Figure 16: Location of tower on podium from the Development Plan compared to the proposed 'S' shape tower form.

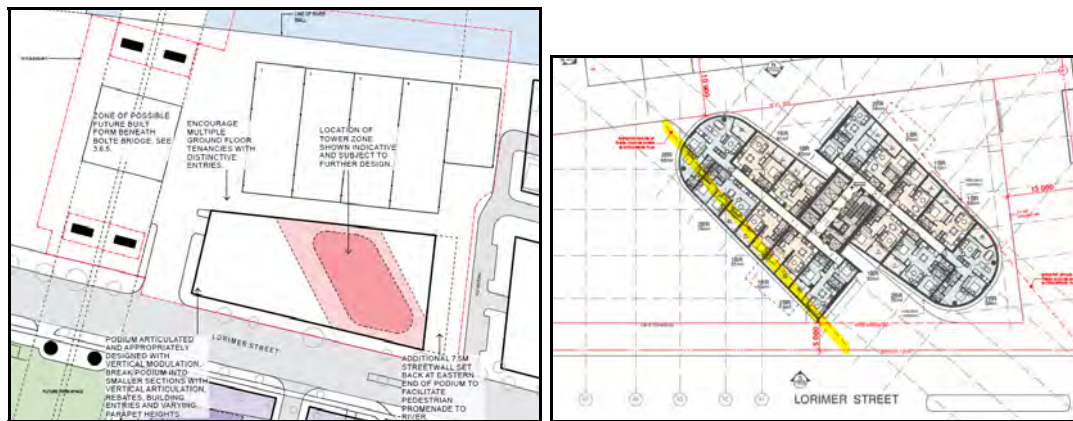
- The Development Plan provides an indicative tower form and general siting above the podium which can be seen above.
- The proposed tower is generally consistent with the tower envelope noting the encroachment outside the envelope to the west which is considered to be minor.

Figure 18: Location of active and non-active frontages generally consistent with the Development Plan

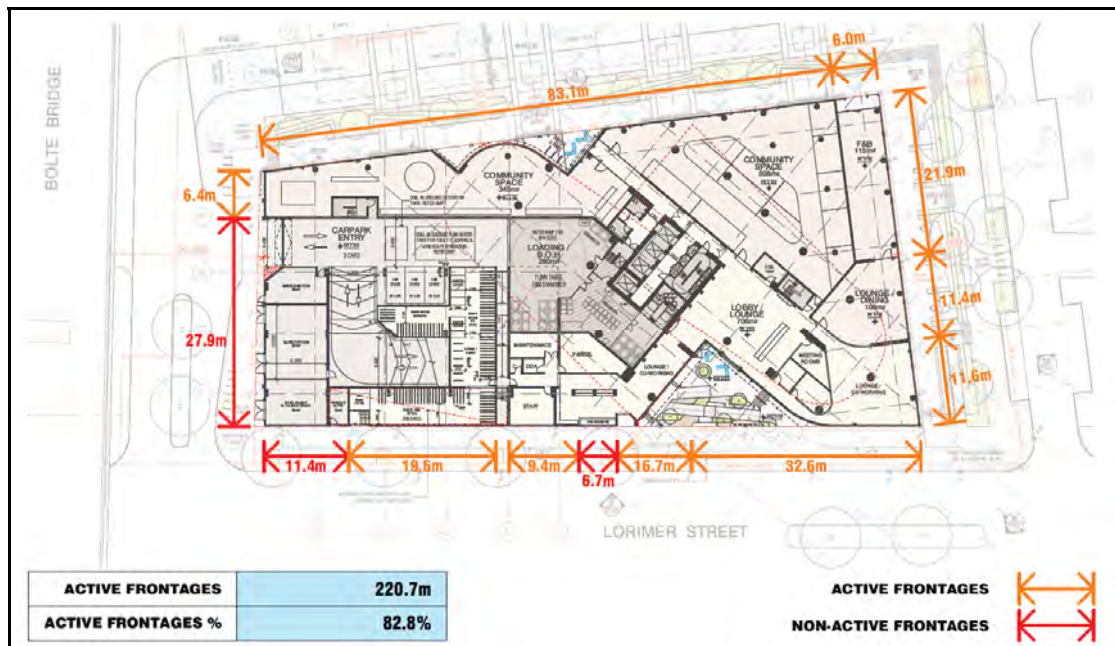
- The ground floor accommodates an area of 853 m<sup>2</sup> as community service space.
- The proposal provides 82.8% of active frontages at the ground floor level, however, an increase in activation is required to the west. The accumulation of the building's services such as substations and vehicle access impact on the visual interest to this façade. The officer recommendation includes a condition to increase activation of this interface.

Figure 19: Shadowing from proposed built form compared with indicative Development Plan shadow diagrams

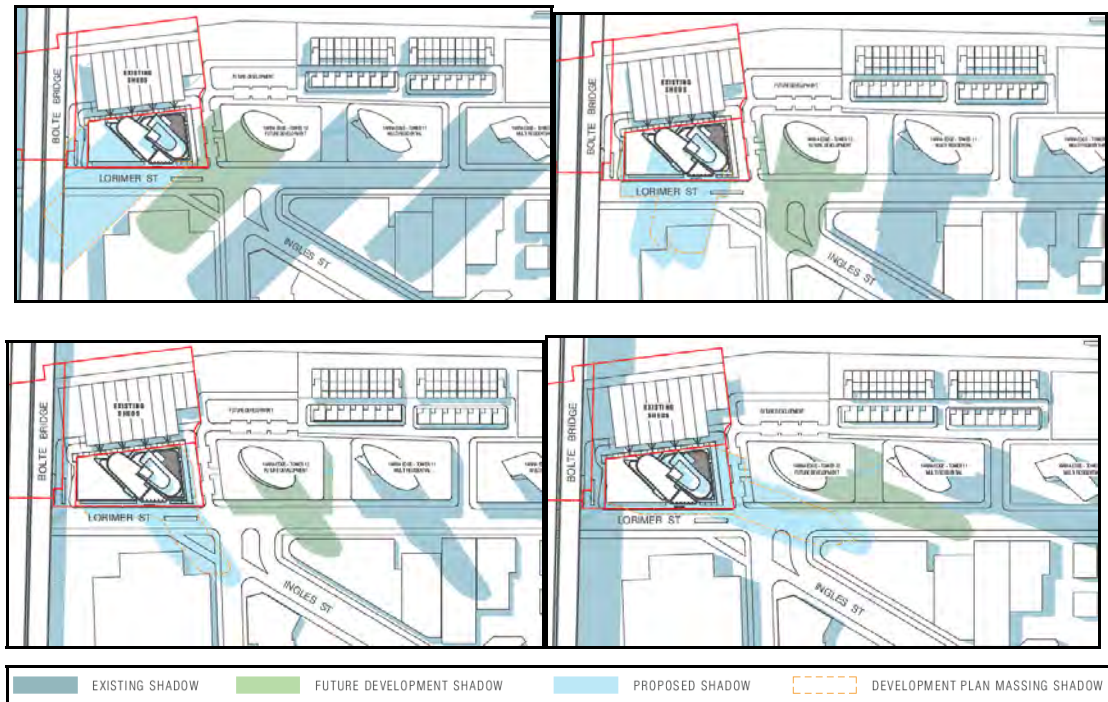
- The shadowing diagrams provided within the Development Plan are acknowledged to be indicative. Notwithstanding, the proposed shadows generally follows the outline anticipated by the Development Plan.

- While the extent of shadow extends beyond that of the Development Plan it does not create any unreasonable offsite amenity impacts noting that the impacted areas are predominately to the Bolte Bridge, Lorimer Street and Ingles Street road reserves.

Figure 25: Level 2-5 corridors

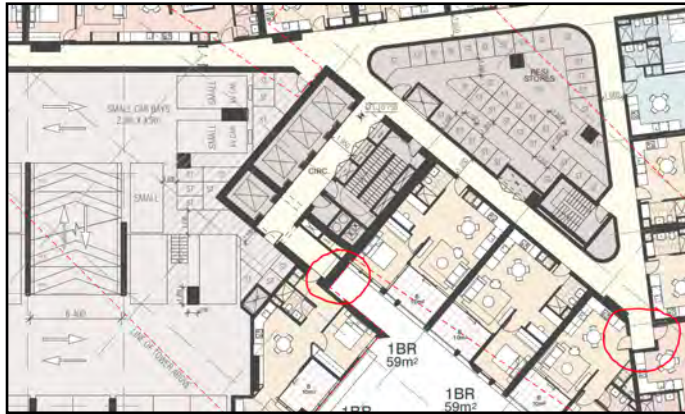
The proposal meets the objectives of Clause 58.05-2, however, does not achieve full compliance with Standard D19 with regard to providing natural ventilation within some of the corridors.

Of particular concern is the lack of natural ventilation for the corridors associated with Levels 2-5. The areas of concern are outlined in red below.

It is considered reasonable for the proposal to achieve strict compliance with Standard D19. This would not only result in improved ventilation but also result in access to natural light for these corridors. Modifications to the corridor and potential minor layout changes are considered achievable and therefore the officer recommendation includes a condition for the proposal to be compliant with Standard D19.

Figure 26: Example dwelling where Standard D29 is not achieved, however, ventilation opportunities are still available due to extent of windows in dwellings

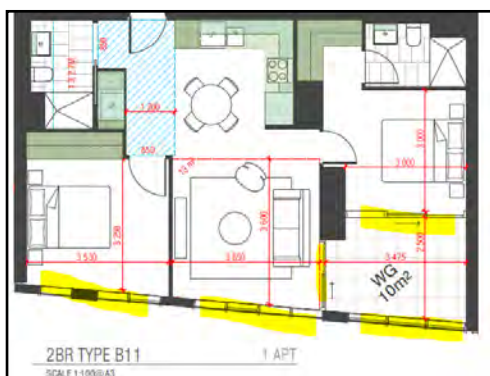
The proposal does not achieve compliance with Standard D29 as only 30% of the dwellings have appropriate cross ventilation rather than 40%.

Dwellings that do not meet the technical requirements of the Standard continue to achieve an acceptable level of natural ventilation, as they are shallow in depth and provide for multiple windows which often face different aspects. As a result this outcome still allows for breeze paths. Further, all dwellings within the building are provided operable windows which allow for occupants to effectively manage the natural ventilation of their dwelling.
